Title: Capture of near-critical debris flows by flexible barriers: an experimental investigation

MS No.: egusphere-2024-3575

Third referee comments and replies -(June 13th 2025)

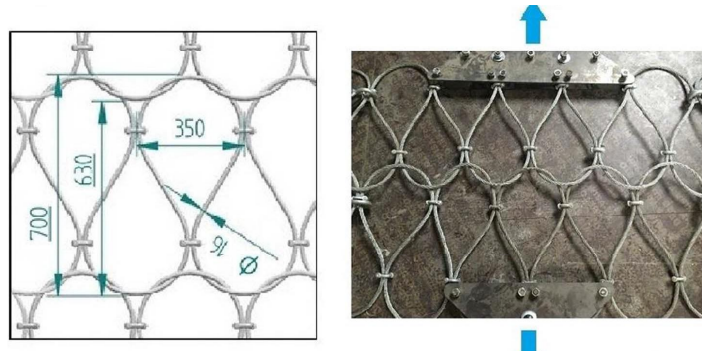
5. Pg 4, Para 95: Provide citation for the mixture composition of the “real debris flow” from field cases in Alpine region.

The criteria we followed and our references are now clarified as follow: “The characteristics of the mixture (wide grain size distribution, clay into the interstitial fluid, water content <50%) were determined to mimic coarse-grained debris flow with a high solid fraction commonly found in Alpine region (Coussot and Meunier, 1996; Hürlimann et al., 2003; Brenna et al., 2020).”

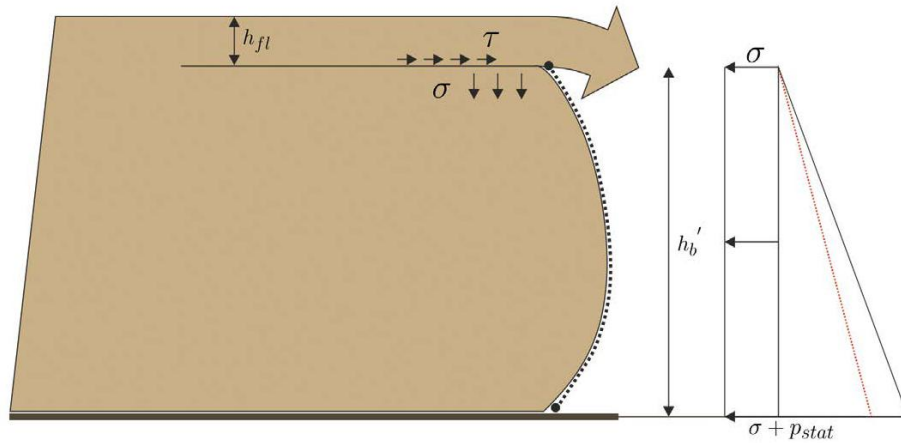
15. Pg 20: In addition to verifying that parabolic assumption is appropriate using calculated force, can you use the measured peak deflections of cables to provide evidence?

As evidenced in Figure 10, the elongation of the cables experienced no significant variation after reaching its peak value. Besides, no images were taken during the event to measure the barrier deflection. Last, the peak value of the force was not precise enough for being used in this study. As a consequence, the authors regret they can't go further here.
